Jordan Springs East (JSE), Penrith

1. Further to your request, you have asked the writers for a joint answer to the question “Is the fill at Jordan Springs East Development controlled fill or uncontrolled fill?”
2. We confirm that we are aware of the instructions of the Expert Witness Code of Conduct, Uniform Civil Procedure Rules (UCPR) in Part 31 Division 2, and the Expert Witness Code of Conduct, Schedule 7 of the UCPR, and that these have been read and understood. The writers are specialists in the field of geotechnical engineering, with particular expertise in unsaturated soil mechanics.
3. The following is given:

Figure 2: Density Ratio vs RL for all tests within the dashed area shown in Figure 1

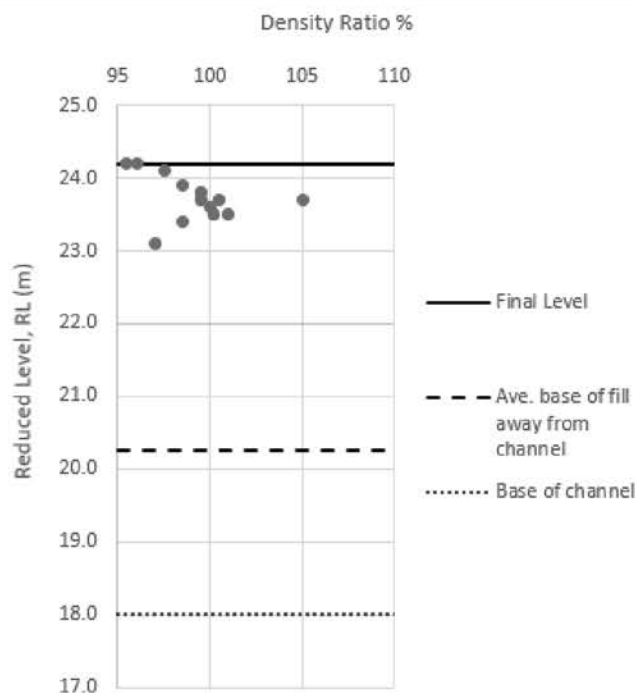
39. It can be seen from Figure 2, no tests were carried out in this area of JSE for the lower 5 m of fill, and that the only compaction tests that were carried out were confined to approximately the upper 1 m of the fill.

40. For an area of 4,400 m², the Douglas Partners specification requirement of 1 test per layer per 1500 m² means that $4400/1500 \approx 3$ tests per layer are needed. For a fill thickness of 5 m and a compacted layer thickness of 250 mm, the number of layers is $5000/250 = 20$. Therefore, the Douglas Partners specification requires the number of tests over this 5 m depth of fill should have been about 20 layers x 3 tests/layer = 60 tests, rather than no tests.

41. This indicates that deep fill was placed in the Armoury Road area without the testing as required by the earthwork's specifications. The compaction and quality of this deep fill is therefore unknown. The Douglas Partners Earthworks certifications (References h and j), at least in this area of JSE, therefore do not give an accurate indication of the actual condition of the fill, and so are unreliable.

Figure 3: Area within Stages EW6.1 and EW 6.2, and approximately centred by Lot 3022, where compaction test results within the backfilled channel were examined

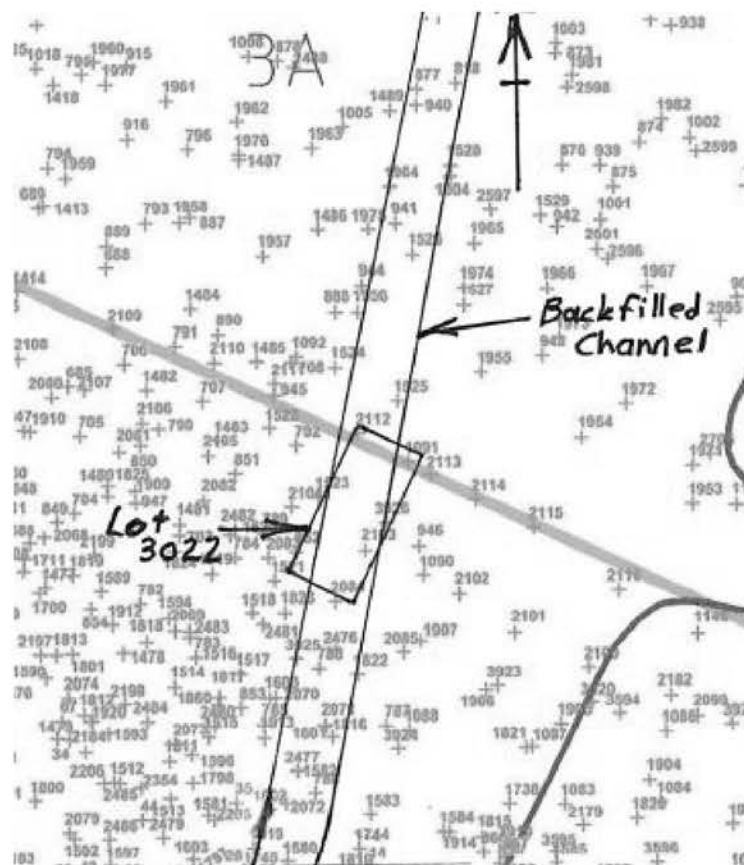
46. Lot 3022 Poynting Street is in stage EW6.1, at the boundary with EW6.2. The site is known to straddle over a back-filled unnamed channel, orientated roughly in a north-south direction, as shown in Figure 3. Figure 3 also shows the locations of compaction tests in the vicinity of Lot 3022.

Figure 4: Density Ratio vs RL for all tests within backfilled channel in the vicinity of Lot 3022 (see Figure 3)

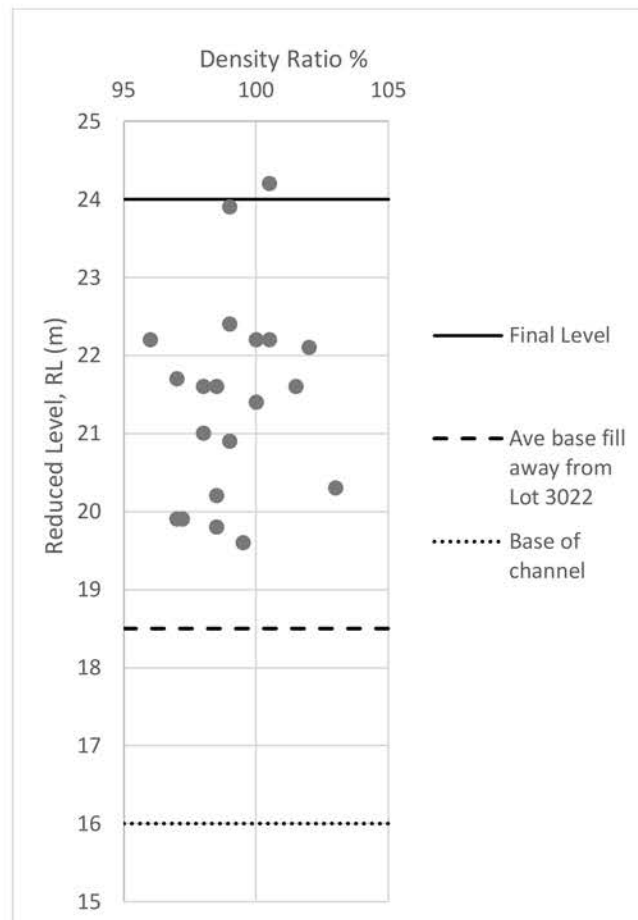
52. From Figure 4, for the ground surface at RL 24 m, for up to an 8 m depth of fill, the base of the fill will be at about RL 16 m. No tests have been conducted in the lower 2.5 m of fill in the channel.
53. By the Douglas Partners specification requirement of 1 test per layer per 1500 m², for a compacted layer thickness of 250 mm, the number of tests required over the 2500 m² area for this lower 2.5 m depth of fill, is $(2500/1500) \times (2500/250) \approx 17$, rather than no tests.
54. Therefore, it is concluded that the backfilling, at least in the deeper sections of the channel, was not carried out with the testing required by the earthwork's specifications.

Figure 5: Area within Stage EW4.2, and approximately centred by Lot 1307 where compaction test results were reported

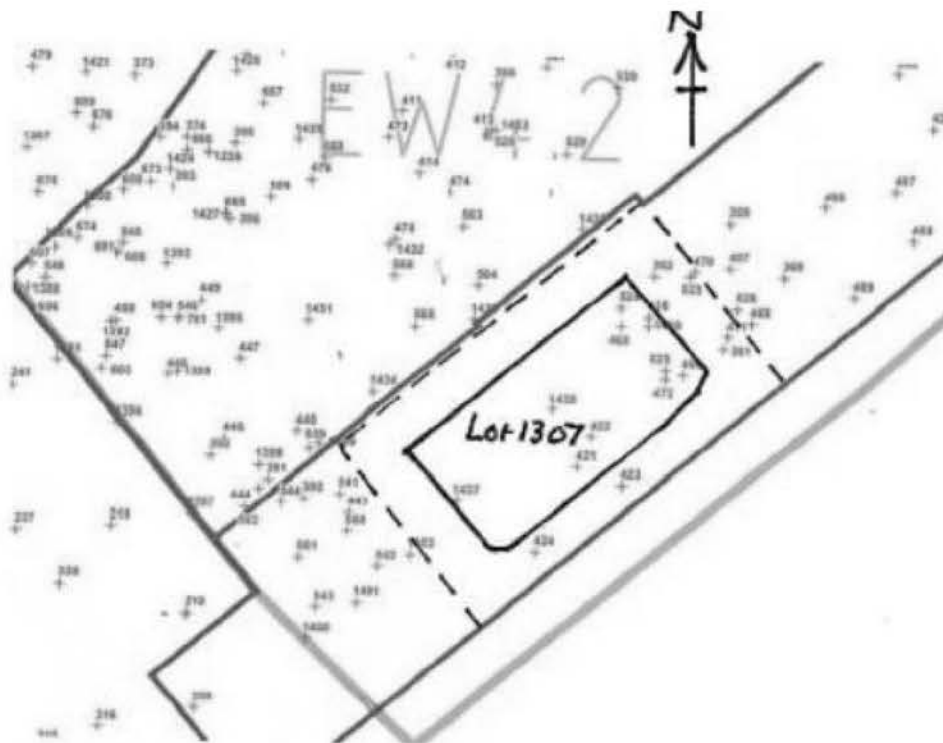
55. Lot 1307 Colonel Way is at the south-eastern corner of stage EW4.2, just outside the ARRA area. The location is shown in Figure 5. Figure 5 also shows the locations of compaction tests (from Reference j) in the vicinity of Lot 1307.

Figure 6: Density Ratio vs RL for all tests within the vicinity of Lot 1307 (see Figure 5)

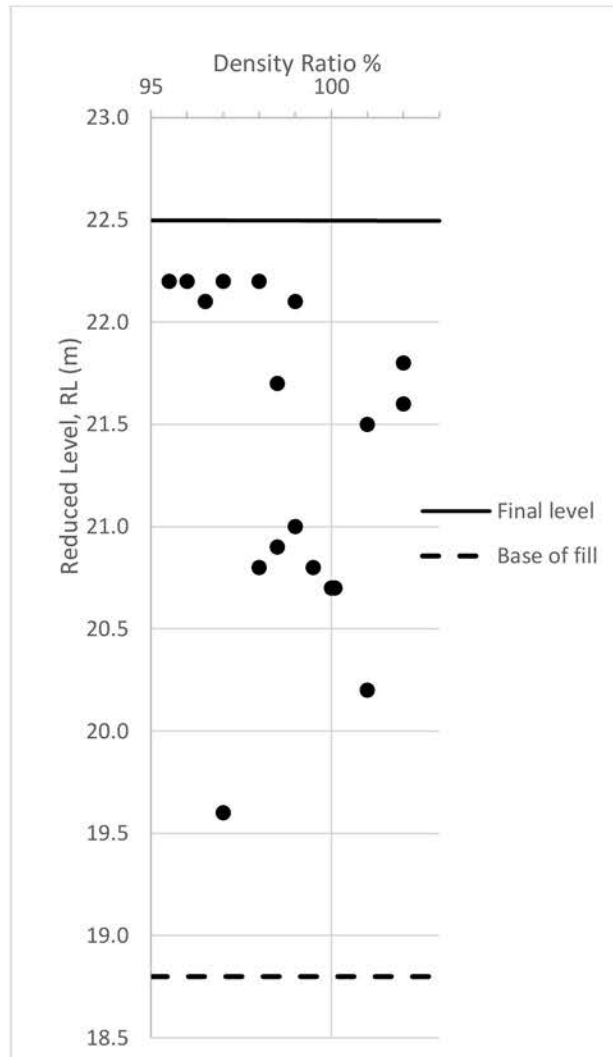
61. Several conclusions are made from Figure 6 as follows:

- For a ground surface at RL 22.5 m, and for up to a 3.7 m depth of fill, the base of the fill will be at about RL 18.8 m. No tests have been conducted in the lower 800 mm of fill. For this area of 4,500 m² and a compacted layer thickness of 250 mm, by the Douglas Partners specification of 1 test per layer per 1500 m², the number of tests required over this 800 mm depth of fill is $(4500/1500) \times (800/250) \approx 10$,
- Only 2 tests over the entire area have been carried out below RL 20.7 m (i.e., all but 2 tests have been carried out in the upper 1.8 m of fill). For this area of 4,500 m² and a compacted layer thickness of 250 mm, by the Douglas Partners specification of 1 test per layer per 1500 m², the number of tests required over this lower 1.9 m depth of fill is $(4500/1500) \times (1900/250) \approx 23$, and
- The lift thickness appears to be up to about 500 to 800 mm.

62. It can be concluded from Figure 6 that the earthworks, at least at several locations in the area of Lot 1307, was not in accordance with the earthwork's specifications, as there were insufficient tests. The level of fill compaction is therefore unknown at several locations at this site.

Figure 7: Area within Stage EW1, and approximately centred by Lot 1026 where compaction test results were examined

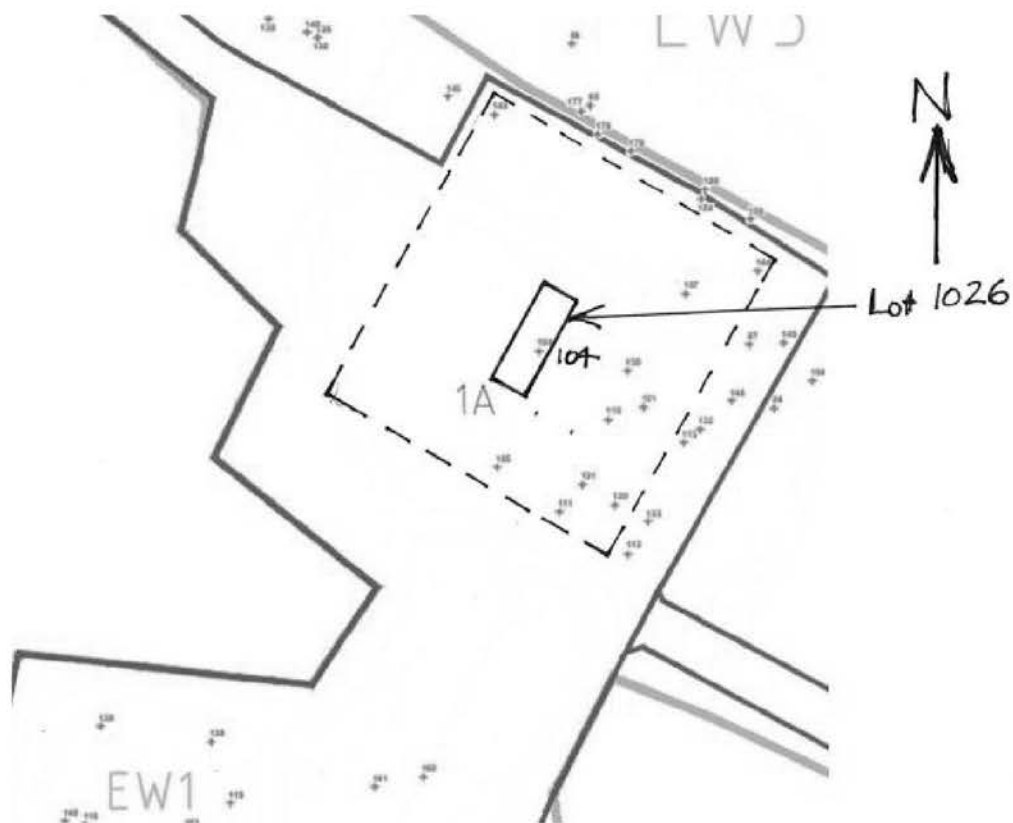
63. Lot 1026 is located at the northern edge of Stage EW1, as shown in Figure 7. Figure 7 also shows the locations of compaction tests (from Reference g) in the vicinity of Lot 1026.
64. From Reference (y), the depth of fill on this allotment varies up to 1.5 m and the ground surface is at about RL 28.5 m.
65. Within the area of about 10,000 m² including and surrounding Lot 1026 as shown bounded by the dashed line in Figure 7, we have determined from Reference g, the compaction test result at every location tested.

Figure 8: Density Ratio vs RL for all tests within the vicinity of Lot 1026 (see Figure 7)

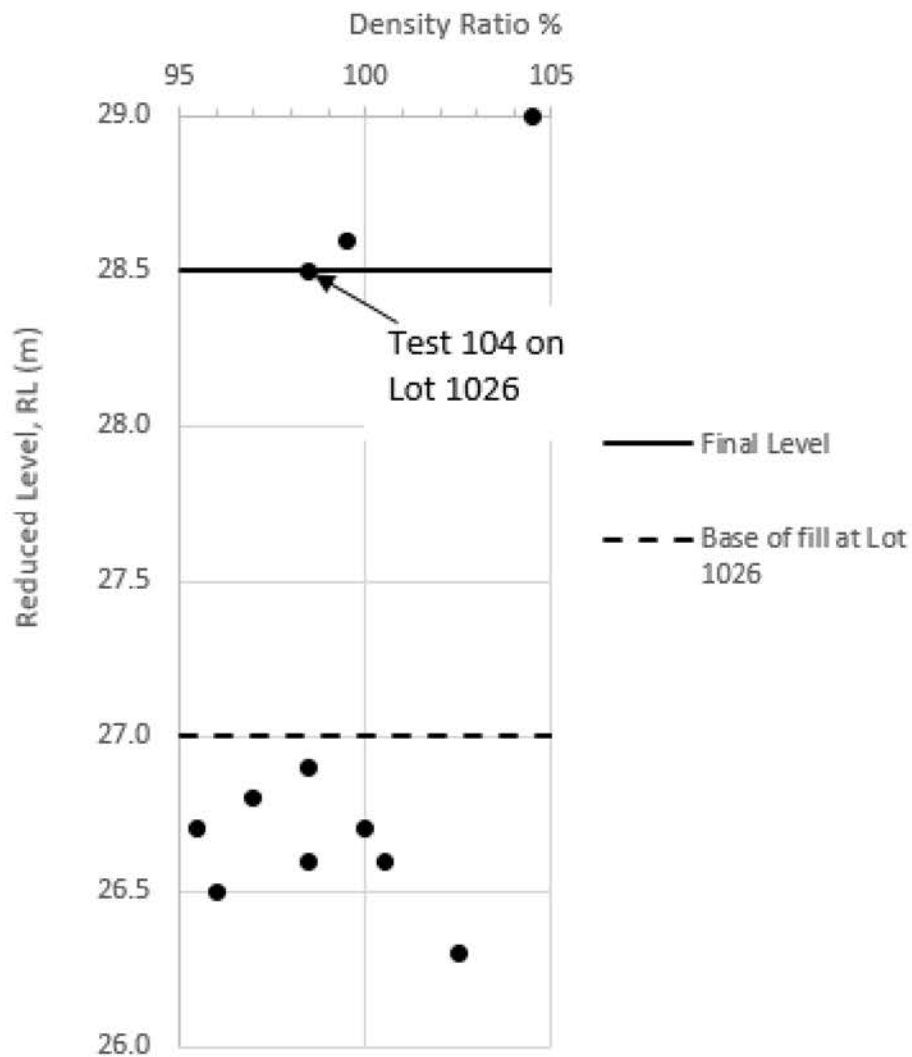
68. Several conclusions are made from Figure 8 as follows:

- Only one test (test 104) was carried out on the actual allotment, and this was taken at the top of the fill, and
- No tests are reported for up to about 1.6 m thickness of the fill. As the fill thickness on Lot 1026 is up to about 1.5 m, this is a serious inadequacy.

69. For the area of 10,000 m² considered here, and an average fill thickness of 1.5 m, for a compacted layer thickness of 250 mm, the Douglas Partners specification of 1 test per layer per 1500 m² requires the number of tests to be $(10000/1500) \times (1500/250) \approx 40$.

70. It is concluded from Figure 8 that the earthworks, at least in the area of Lot 1026, had insufficient testing during construction, so that the quality of the fill is unknown for considerable sections.

Figure 9: Area within Stage EW 7, and approximately centred by Lot 3125 where compaction test results were examined

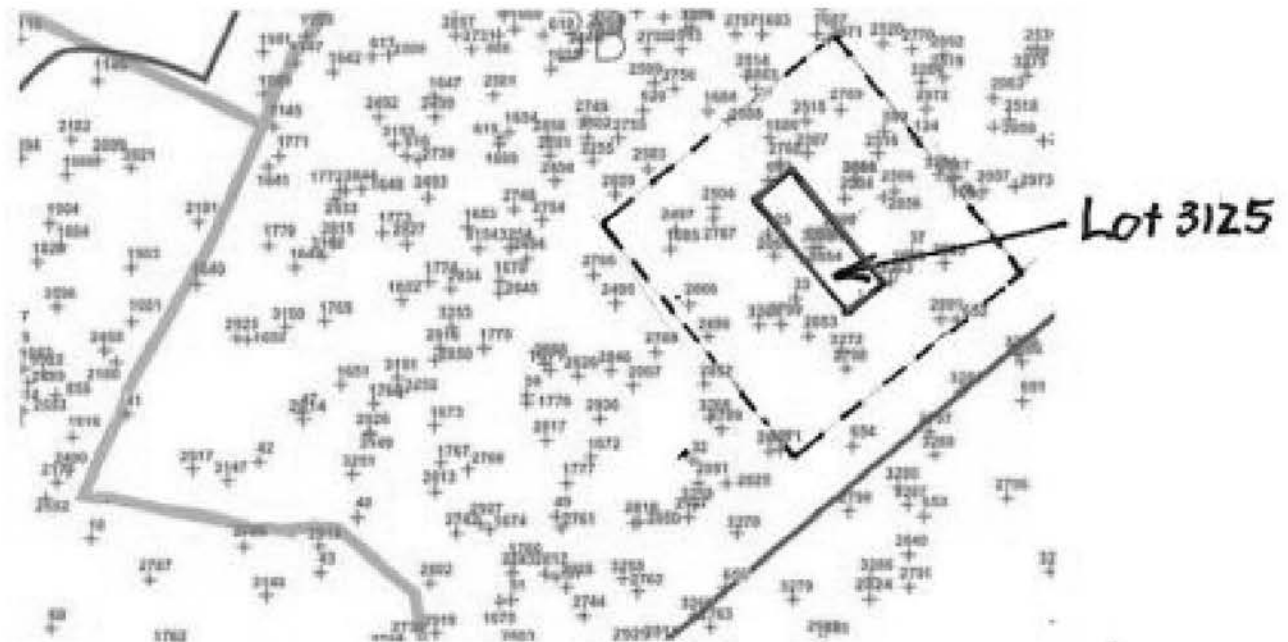
71. Lot 3125 is located within Stage EW7, as shown in Figure 9. Figure 9 also shows the locations of compaction tests (from Reference n) in the vicinity of Lot 3125.

Figure 10: Density Ratio vs RL for all tests within area shown in Figure 9

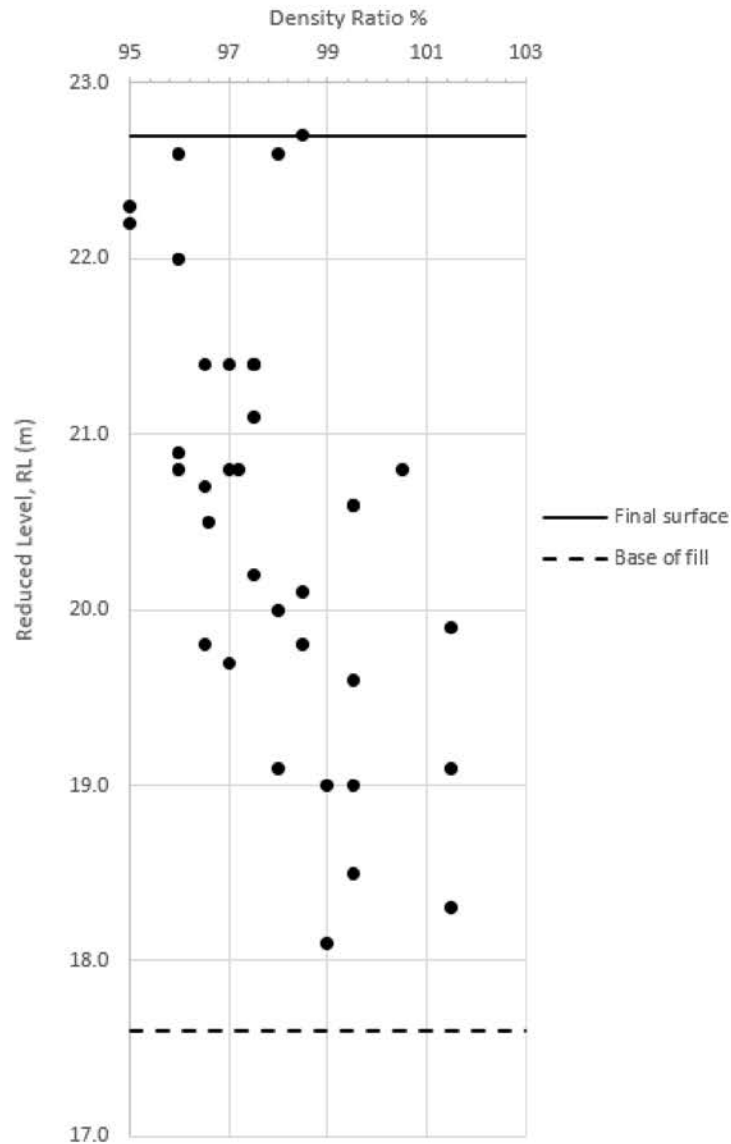
78. Several conclusions are made from Figure 10 as follows:

- For a 5.1 m depth of fill, and a ground surface at RL 22.7 m, the base of the fill will be at about RL 17.6 m. Only 3 tests over the 3100 m² area were carried out below RL 19 m (i.e., the lower 1.4 m of fill). By the Douglas Partners earthwork's specification of 1 test per layer per 1500 m², for a compacted layer thickness of 250 mm, at least about 11 tests (i.e., $[3100/1500] \times [1400/250]$) should have been taken in the lower 1.4 m of fill, and
- The lift thickness appears to be up to about 500 mm to 600 mm. This lift thickness exceeds the maximum specified without confirmatory tests that the compaction is uniform over this layer thickness.

79. These observations indicate departures from the earthwork's specification, particularly at the lower levels of the fill, meaning that there is uncertainty on the quality of earthworks at these levels.

Figure 11: Area within Stage EW 6.2, and approximately centred by Lot 3044 where compaction test results were examined

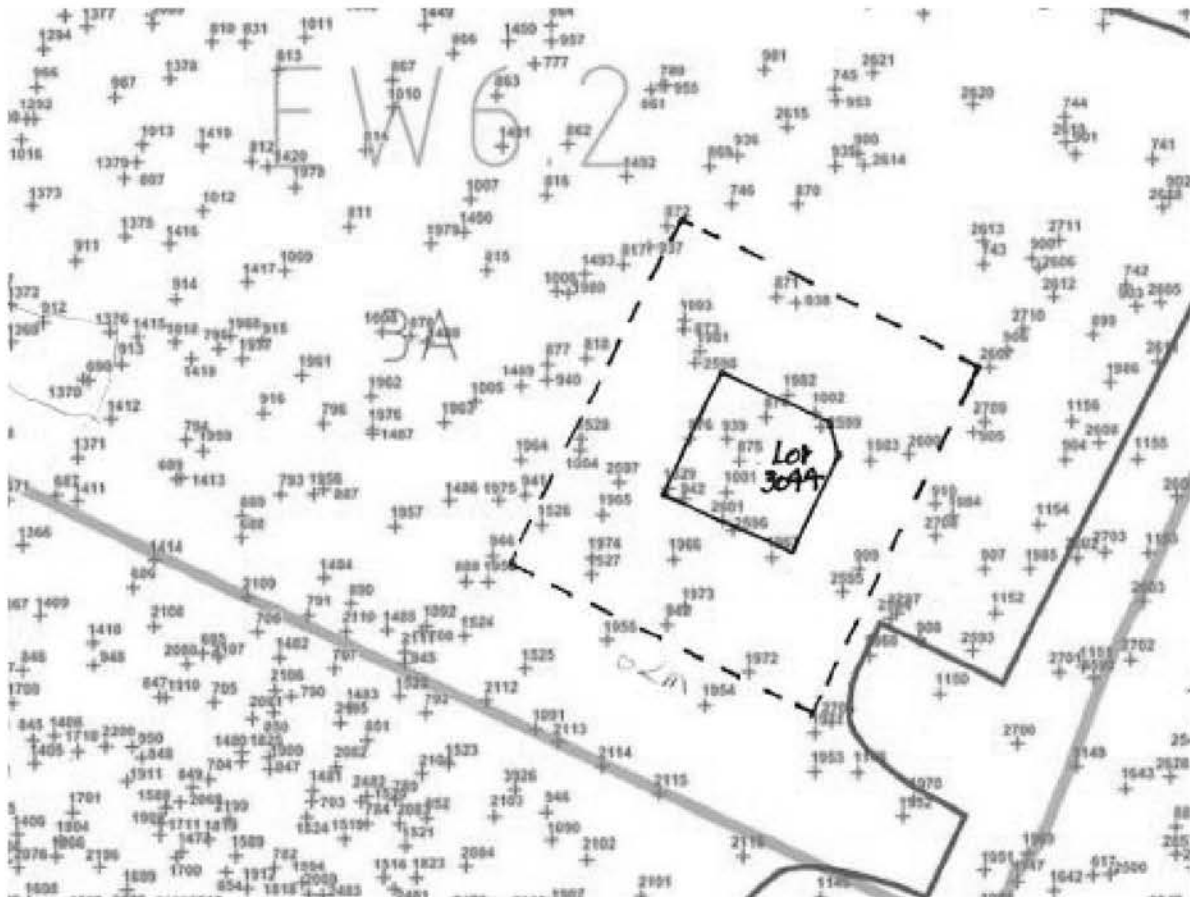
80. Lot 3044 is located within Stage EW6.2, as shown in Figure 11. Figure 11 also shows the locations of compaction tests (from Reference m) in the vicinity of Lot 3044.

Figure 12: Density Ratio vs RL for all tests within the vicinity of Lot 3044 (see Figure 11)

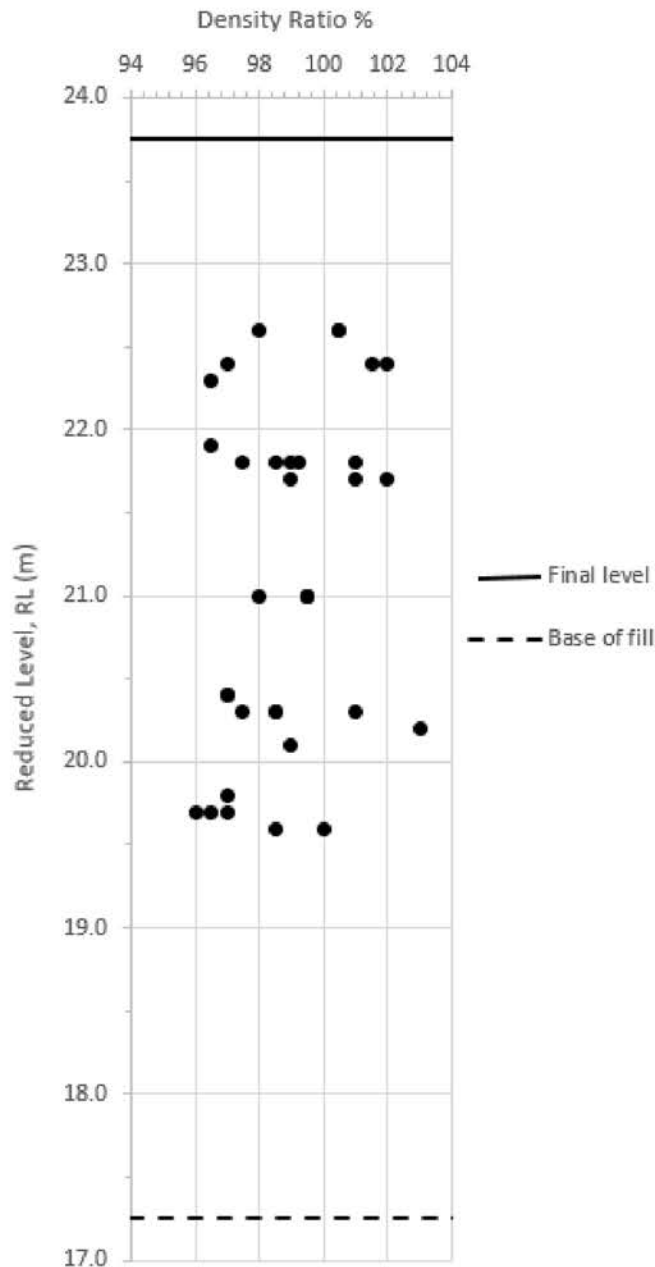
87. Several conclusions can be made from Figure 12 as follows:

- For up to 6.5 m depth of fill, and a ground surface of about RL 23.75 m, the base of the fill will be at about RL 17.25 m. No tests have been conducted in the lower 2.3 m of fill. By the Douglas Partners specification of 1 test per layer per 1500 m², for a compacted layer thickness of 250 mm, the number of tests required over the 4400 m² area for this lower 2.3 m depth of fill is $(4400/1500) \times (2300/250) \approx 27$, rather than no tests,
- No tests are reported for the upper 1.0 m thickness of the fill, and
- The lift thickness appears to exceed 500 mm in parts, which is greater than that specified.

88. It is concluded from Figure 12 that the earthworks, at least in parts of the area of Lot 3044, had insufficient control during construction, so that the quality of the fill, in parts, is uncertain.
